PCN: V19-005-F48070-MA

Product Change Notice

Implementation of new Software version for AFBR-S50MV85G, new lens colour, new pin design and implementation of second assembly location

AFBR-S50MV85G
AFBR-S50MV85G-EK

Current situation:

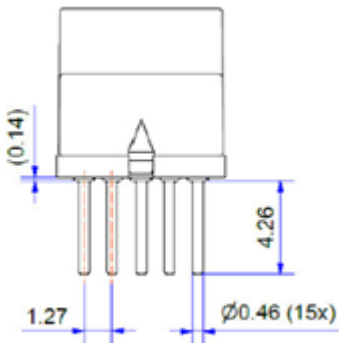
- Software version 0.9.5
- Lens colour black
- Pin diameter 0,46mm with 0,14mm flange
- Product assembly in Europe

Change:

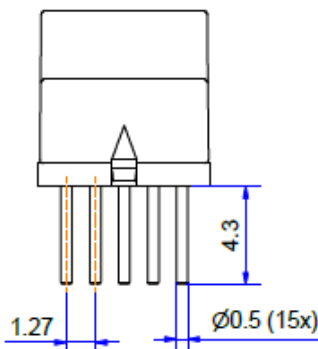
- Software version 1.0
- Lens colour transparent
- Pin diameter 0.50mm without flange
- Product assembly in Europe and Asia

- Improved device functionality, improved ambient light suppression, improved temperature stability, improved voltage robustness and allow higher APD gains
- Improved mechanical stability
- Ensure production capacity with increasing customer demand
